Ref No. INST/12(3)/2020-Pur

CORRIGENDUM

Reference to NIT no. INST/12(3)/2020-Pur published in national newspapers for purchase of equipment: 10000 Class Cleanroom with Air Shower, Scrubber, Gaslines and Fume Hood. Below mentioned technical points may be read and corrected as per following:-

Tentative lab design:

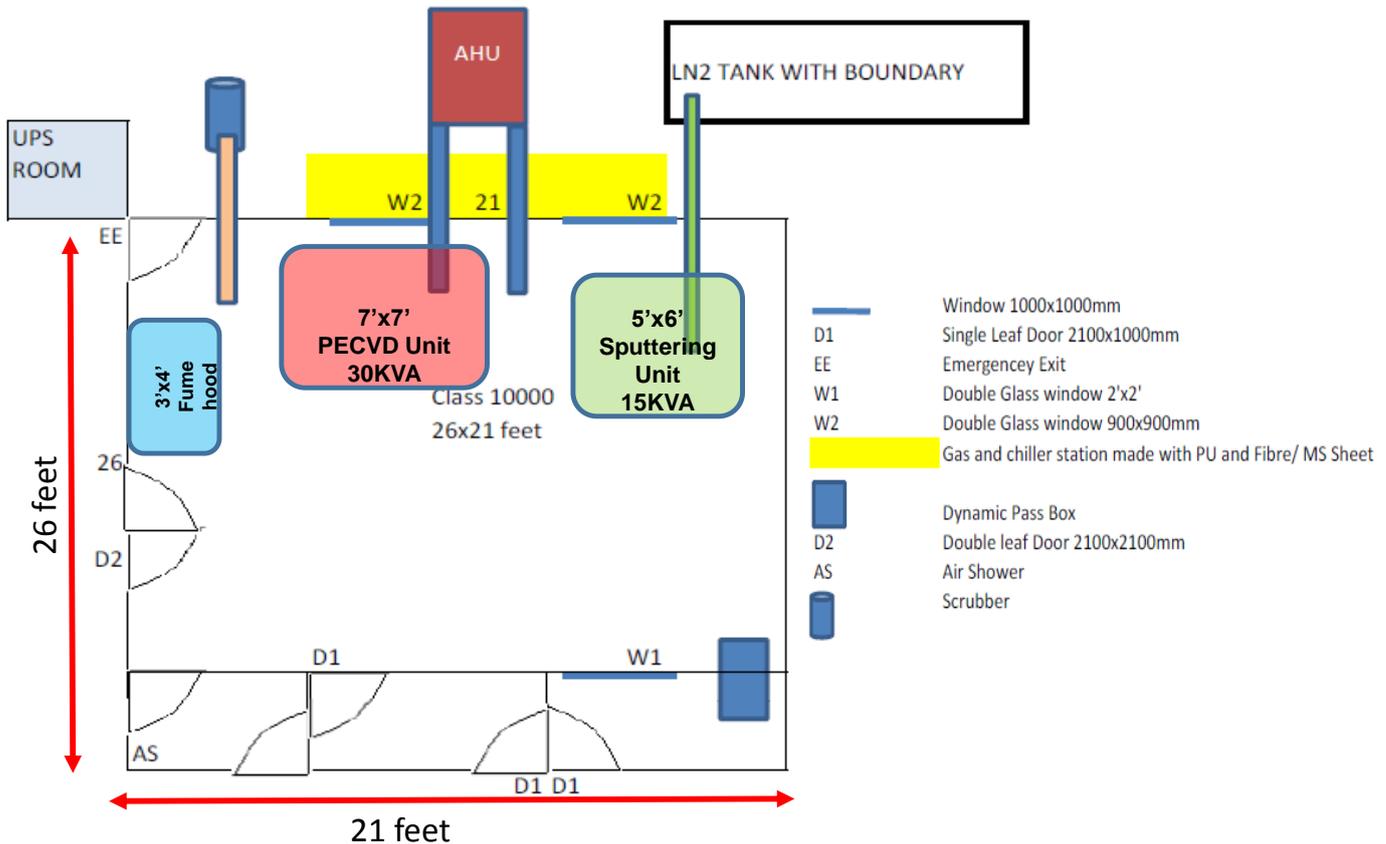
1. Layout of lab is attached. The vendor may visit the site for evaluation
2. Make of materials to be used in lab.
Electricity Havells/ Finolex/ Schneider/ Hager/ Legrand/ Wipro/ Phillips or equivalent.
For Chiller or ODU Diakin/ Carrier/ Bluestar or equivalent.
Blower motor Kruger or equivalent.
For other items also the materials from reputed brand should be used.

One AHU for complete lab with 4500CFM capacity with positive air pressure as mentioned in layout. HVAC system should have minimum 9 HEPA filters complete with ducting, Dampers, housing etc. Institute will not provide anything other than space. Everything needs to be provided by vendor. We need maximum 50-55% humidity. If required please add dehumidifier. Minimum 15% fresh air to be added in each cycle. The material of dampers can be of Aluminum or GI.
